Product Change Notification: P-24-025970

Packaging box dimension and quantity change

Packaging change PN x-929080-y

from 973058-3 to 973057-2

DOCUMENTATION PACKAGING:

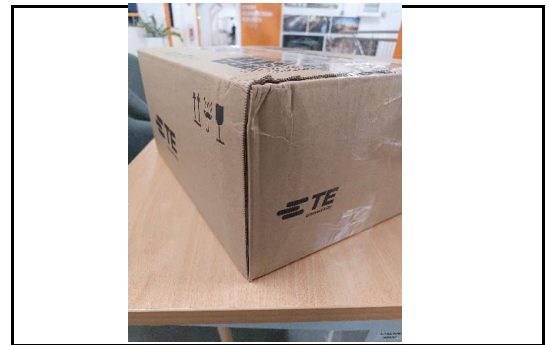
TEST PROCEDURE			
Drop	Standard-Level		Pass / Fail / Comments
1	Corner 3 - 4 - 5		Dented box corner.
2	Edge 3 - 5		Dented box corner.
3	Face 5		PASSED
4			
5			
6			
7
